# UNITED STATES PATENT AND TRADEMARK OFFICE

| APPLICATION NO. | FILING DATE | FIRST NAMED INVENTOR | ATTORNEY DOCKET NO. | CONFIRMATION NO. |
|-----------------|-------------|----------------------|---------------------|------------------|
| 10/767,642      | 01/29/2004  | Scott P. Steinmann   | 630666.91179        | 5403             |

# Office Action Summary

## DETAILED ACTION

# Attachment #1 (marked up)

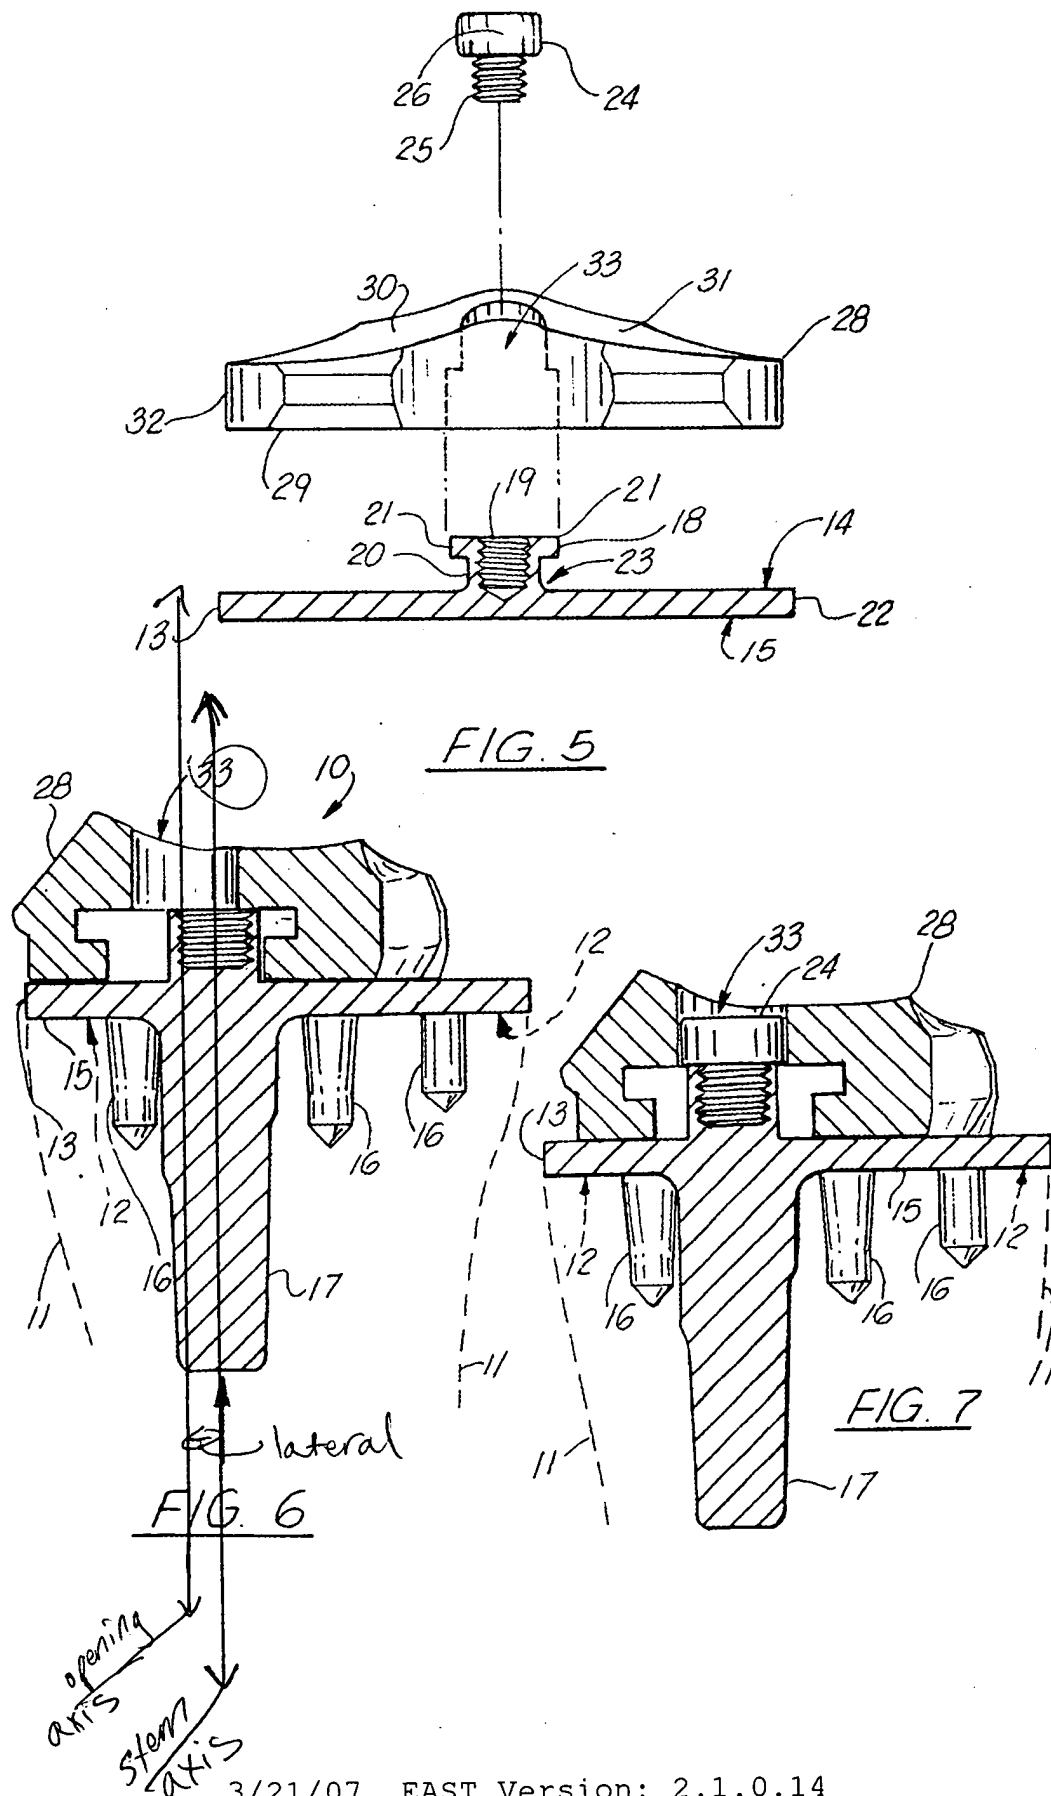
Claims 1, 2, and 5-10 are rejected under 35 U.S.C. 102(e) as being anticipated by Evans et al. (US 6,428,577 B1). Evans discloses a prosthesis (10) comprising a stem (tibial tray; 18+13+17), a head (insert 28) having an outer wall (exterior surface) defining an interior space (opening 33), wherein the head (28) may be placed over the stem end (end may be considered 18) adapted for transverse and axial movement (see fig.6), the outer wall of the head having at least one opening (33), a screw (24) arranged in each opening (33) adapted to contact the end of the stem (18) and secure the head (28) by constraining axial and transverse movement (seen secured in fig.7), wherein each opening (33) is in a lateral direction to the stem axis (fig.6 shows the opening having an axis extending laterally with respect to the stem axis; see attachment 1) and an interior surface of the head wall is spaced from and end of the stem (seen in both figs.6,7). Evans head (28) is elliptical (fig.1) and concave in shape (see fig.5, 6, 7). Replacement of a radial head is intended use language, the head of Evans is capable of replacing a radial head at the elbow joint.

# Attachment #2 (marked up)

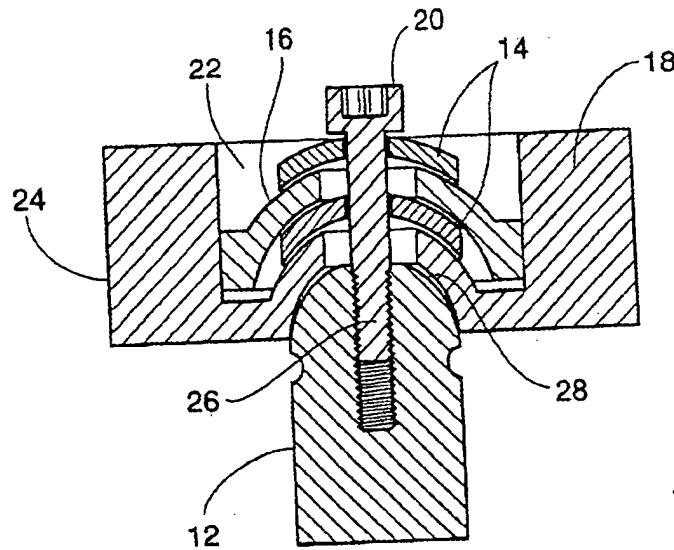
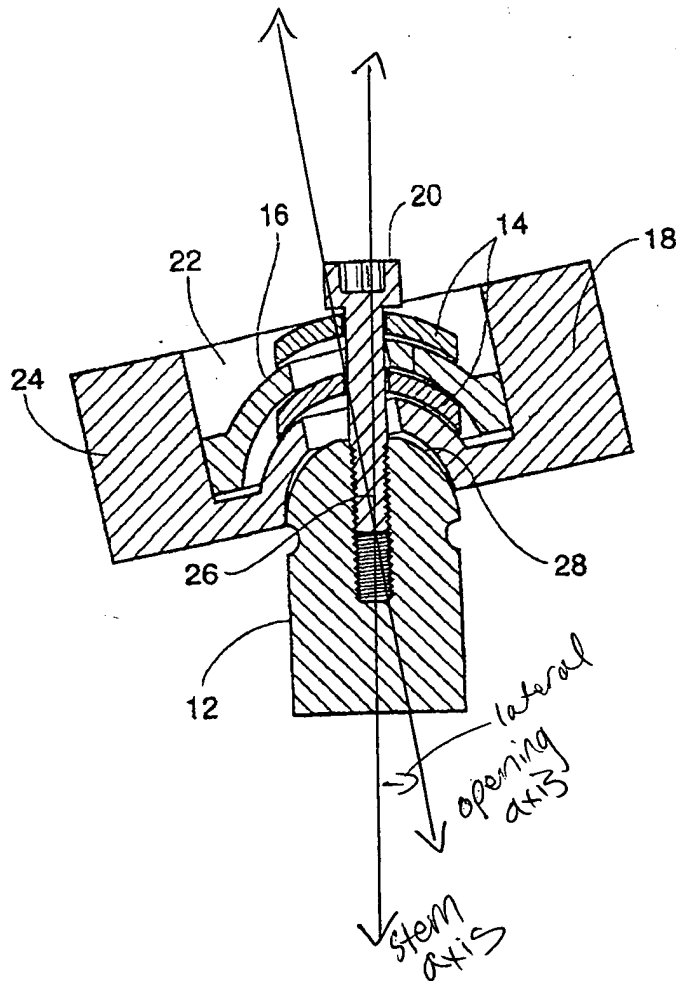
Claims 1, 2, 5, 6, 8, and 9 are rejected under 35 U.S.C. 102(e) as being anticipated by Callaway et al. (US 2002/0120339 A1). Callaway discloses a prosthesis (see figs.3a-5c) comprising a stem (12), a head (18) having an outer wall (24, 22) defining an interior space (cavity 22), wherein the head (18) may be placed over the stem end (12) adapted for transverse

and axial movement (see figs), the outer wall of the head having *at least one* opening (see figs; throughhole in 18), a screw (20) arranged in each opening adapted to contact the end of the stem and secure the head by constraining axial and transverse movement (fig. 5a-5c), wherein each opening is in a lateral direction to the stem axis (fig. 5b opening extends laterally to axis; see attachment 2) and an interior surface of the head wall (22) is spaced from and end of the stem. Replacement of a radial head is intended use language, the head of Callaway is capable of replacing a radial head.
